Note

As of October 1980, the modified screw plug M 38 x 1.5 is installed together with an O-ring.

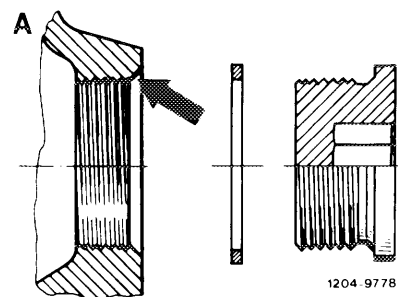
The chamfer in the crankcase was changed for this reason (2nd version).

A 1st version

B 2nd version

When installing a coolant preheater, an O-ring or sealing ring to suit the chamfer in the crankcase should be used.
